HANDOUT #4

DOCUMENT E-4

ADVISORY COMMITTEE INPUT ON CORPS MEASURES AND CONSIDERATION OF LOCALLY IDENTIFIED PROJECTS

May 18, 2009

Measure #4— Nookachamps

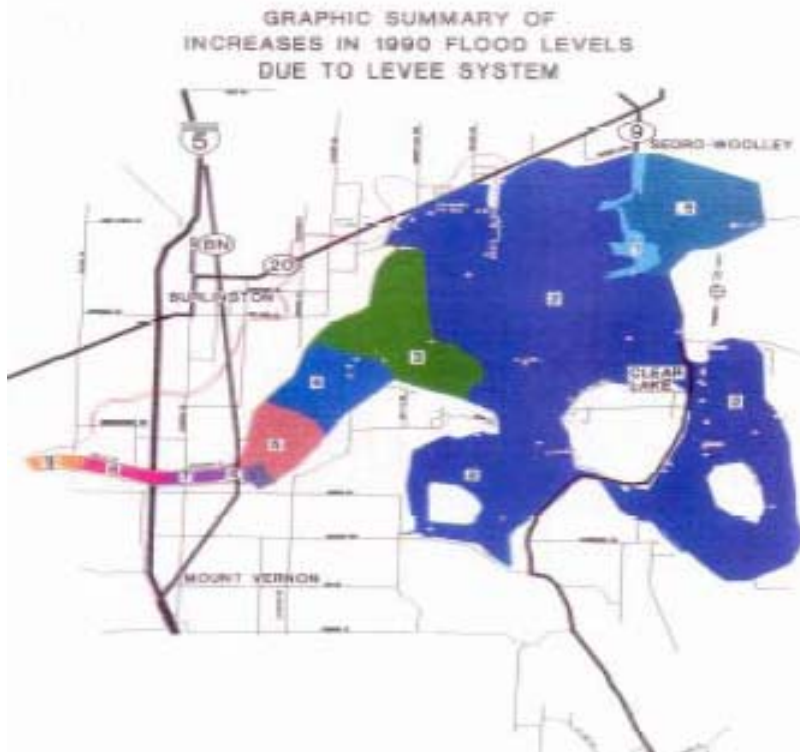
- Technical feasibility is poor because of overflow timing requirements and ability to get water back out of Nookachamps following overflow
- Environmental concerns related to new hardened structures along the river
- Concerns about upstream and downstream impacts
- Any additional consideration would require new design.
- Cost

- Preliminary analysis done was done by PIE. It identified three options.
- Who would do analysis and additional project development if it were turned back to yellow? Corps could not do in timely way.

- PIE project would not increase flood levels, just manage timing. It would need to be done to Corps standards so it would be acceptable for GI. Expensive design. Approach is too mechanical for Corps standards, design didn't fit conditions.

- Improving management of timing of Nookachamps filling has merit. Other redesign elements could include redesigned levees, environmental features.
- Project will induce more severe flooding depths into the artificial storage basin thereby lowering flood levels downstream. (Source: Page 23 Skagit River Flood Reduction Feasibility Study, PIE April 2006)

- Corps of Engineers has been telling us since 1897 to get our levees off the edge of the river. What do these projects do.....they put new levees on the edge of the river.

- There is a 12 foot drop in ground elevation between the Highway 9 Bridge and the Mt. Vernon gage. By taking 8,000 acres out of the floodplain for "minor" flooding events (i.e. narrowing the channel), you increase the velocity of the river in the channel.

- By narrowing the channel you increase the frequency and intensity of "minor" flooding events, (i.e. you would have 1975 to 1990 flood events, depending on the height of the levees on a more frequent basis).

- Between Highway 9 and Strawberry Bar the area is used by Pink (Humpy) and Chum (Dog) Salmon as a spawning area. By increasing the velocity and frequency of the flooding events the redds in those areas will be destroyed.

- Since these will be "new" levees the question has never been addressed as to who will own these levees. Who will maintain them? DD 12? DD 17? All the taxpayers in Skagit County? Perhaps the City of Burlington since they seem to be the only major proponent of the project? This despite the fact that allegedly all they want to do is certify their levees to the 100 year flood level.

- Project is cost prohibitive. Estimated to cost between \$116 million and \$135 million and that's just the construction cost. Estimate does not include the cost for the real estate, flowage easements, environmental enhancement, or operation and maintenance cost. (Source: Skagit River Flood Reduction Feasibility Study, PIE April 2006)

- Project does not meet Corps of Engineers standards; therefore, no money from the Corps will be forthcoming. (Source: Corps of Engineers Preliminary Measures Presentation August 18, 2008).

- Project was looked at by Corps of Engineers in 1966 and again in 2001. Rejected both times, for many of the reasons stated herein but primarily because the project doesn't work. You cannot drain the water fast enough out of the storage area in order to prepare for the second and in some cases multiple flood events that have historically been more severe than the first flood. Why, because the overbank storage is not available. Based on experience in the 1975 (130,000 cfs), 1979 (112,000 cfs), and 1980 (113,000 cfs) flood events, once Francis Road went underwater, it took 4 days to be able to use the road again. A week or more for the water to leave the fields. You really think you can levee the "induced flooding storage area" and drain it more rapidly than it does under natural conditions? The project will have a severe impact to interior drainage.

- In short the project violates all of the three E's: Environment – Detrimental to fish habitat., Economics – Cost prohibitive, Engineering – Doesn't work.
- Some willingness to consider a redesigned Nookachamps project at some later time if it is determined to be a benefit.

Drop from further analysis by GI and CFHMP

Potential Measure #38 - Need interior drainage projects to handle excess flows

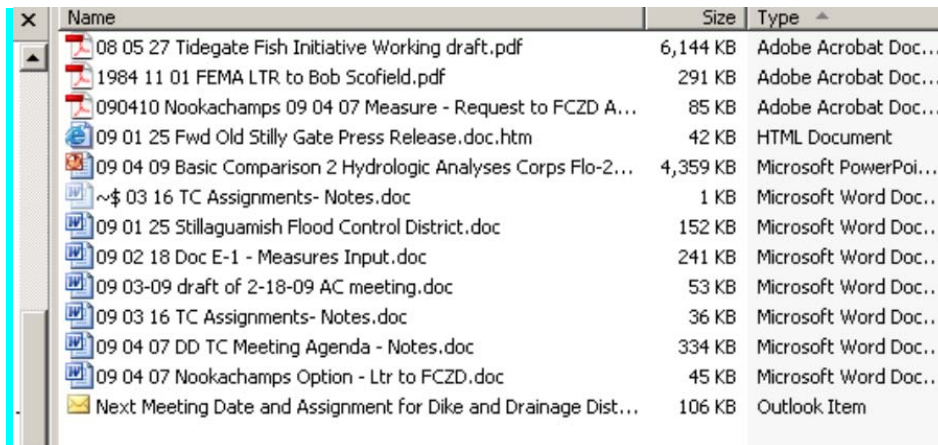
- Need to identify locations to direct overland flow to discharge via control structures into Samish, Padilla and Skagit bays.
- Everything needs to be engineered from the bottom to upstream.
- Drainage or flood damage reduction? Flood damage reduction. Idea is reduce velocity of water coming onto and off the floodplain. And reduce water surface elevation. Increase capacity of drainage system. Also reinforcing the downstream face of road embankments to reduce erosion.
- Big issue if going to address internal drainage from overflow.
- Often requires dike breaching to exit water
- Interior drainage should be addressed in all Corps measures where applicable.

Continued evaluation/project development. Need more project information.
